**OPERATION REPORT
FEDERAL ENERGY REGULATORY COMMISSION
New York Regional Office**

Project Name: Vernon

Inspected by: Liza Vélez and Michael Monahan Date: June 24, 2002

Photo No. 12 - A typical Tainter Gate. This is Gate No. 2 being operated using power from Emergency Generator. Some rust spots were noted. The Licensee's representative stated the rust spots will be painted during the 2003 maintenance season.

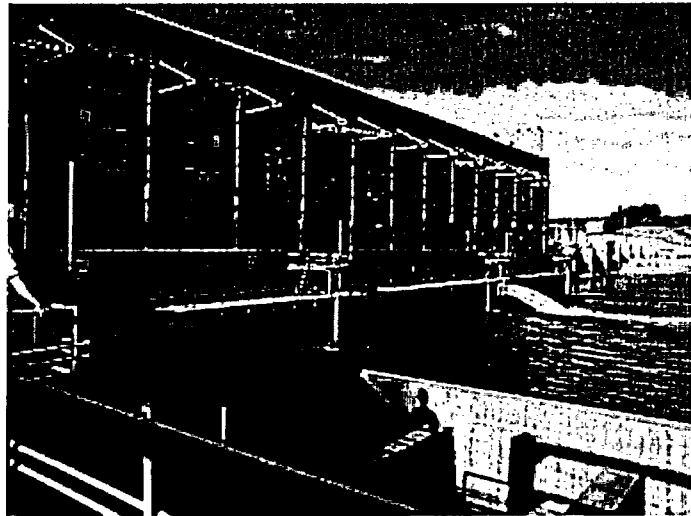
No problems occurred during the gate operation. An automatic Emergency Generator test is performed once per month. At the time of the inspection, all gates were reported to be operational. They appeared to be structurally sound. Rust spots were observed on the tainter gate that will be painted during the 2003 maintenance season.
